Client: Health Lang
Drawing Title: Site Plan
Scale: 1 : 250
Project: Proposed Carpark at 2 Hudson Fysh Dve, Western Junction, TAS

PROJECT: 2 HUDSON FISH DRIVE WESTERN JUNCTION PROPOSED NEW CARPARK THE PROPOSED CARPARK PLAN

From: Melissa Cunningham
Sent: Fri, 29 Jan 2016 15:49:13 +1100
To: Register Email in ECM
Subject: Reminder: Referral to Launceston Airport - Planning Application P15-390

Assessment against the *Northern Midlands Interim Planning Scheme 2013*

JING Engineers & Planners
 2 HUDSON FISH DRIVE
 WESTERN JUNCTION
 PROPOSED NEW CARPARK
 LANDSCAPING PLAN

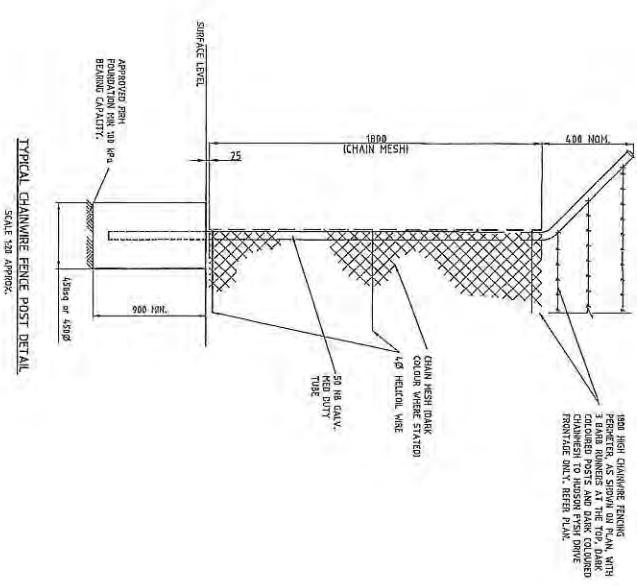
<p>Comment: Does not comply – mounding is not incorporated into the landscaping.</p>	<p>Comment: The landscape plan adjacent to Evandale Main Road consists of two rows of shrubs with a mature height of 3m and one row of shrubs with a mature height of 2m. Given that the majority of the site is ground level carparking, and the maximum height of the building on site is 5.5m, it is considered that the proposed landscaping will provide effective screening of buildings and works from Evandale Main Road.</p>
